Request for Class II Permissive Change

FCC ID: BEJE2242TA

Please be notified that we, the undersigned, LG Electronics U.S.A., Inc. declare that the reasons for this Class II permissive change are as below:

1. To change the PCB of main board

PCB and block compare

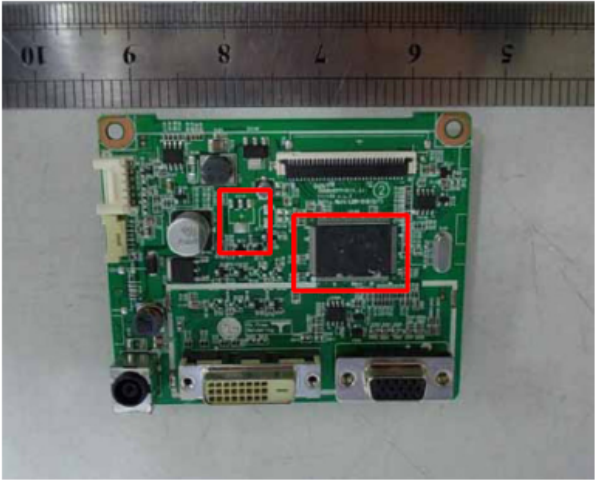
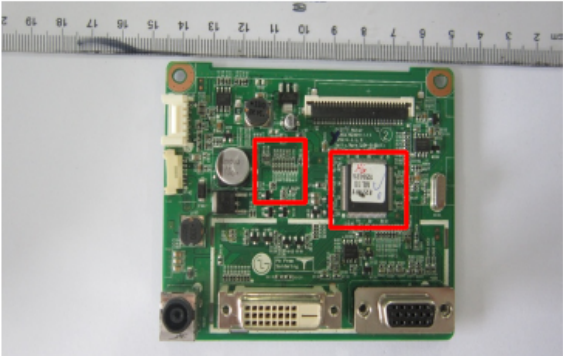
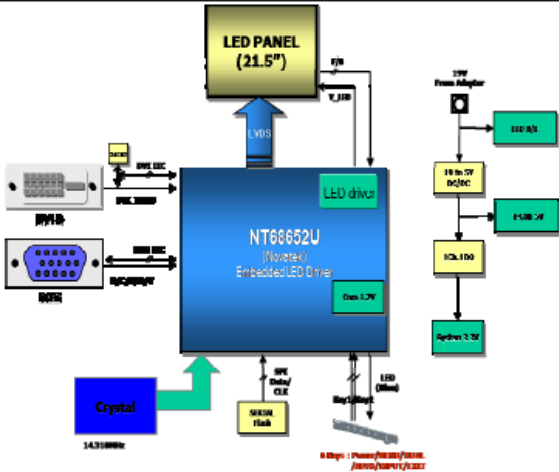
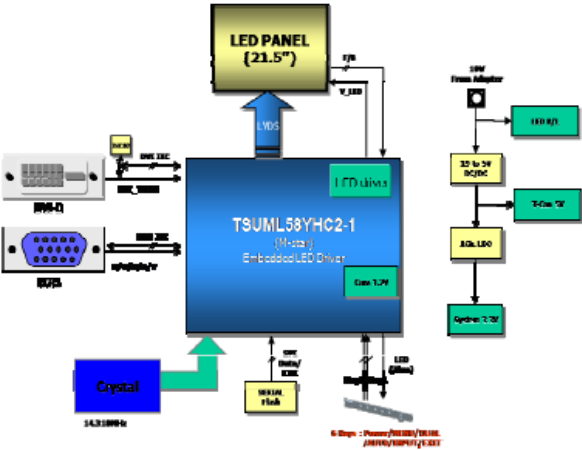
Maker	old	new	Change
PCB Photo			Different: 1. Main IC circuit 2. LED drive
Block			Same : 1)Crystal :same 2) Resolution: same 3)Panel :same 4)Adapter : same

Circuit diagram compare-1

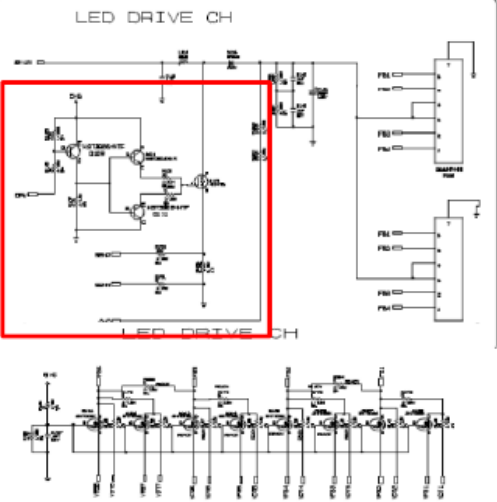
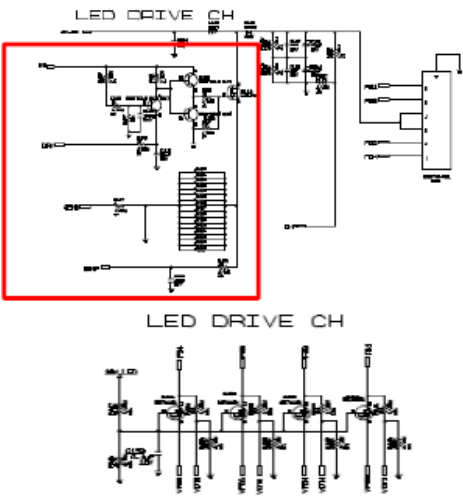
Maker	old	new	Change
Main IC circuit			1) Size: different 2) Pin No.: Same 3) Pin output: change 4) Maker different
LVDS out			Same

Circuit diagram compare-2

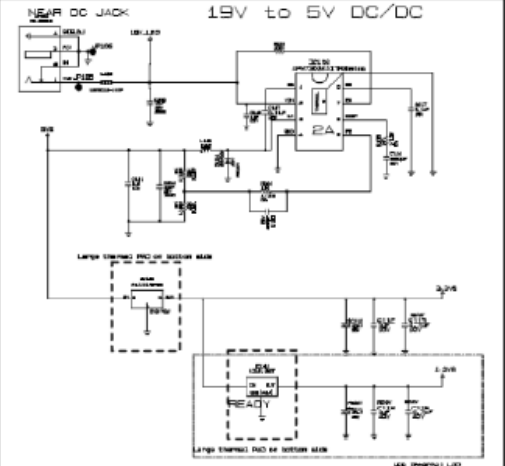
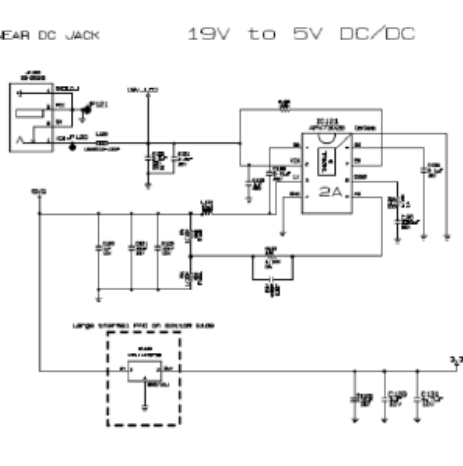
Maker	old	new	Change
LED drive CH			Change : Mos transistor →resistor Reason: cost down
19V to 5V			Same
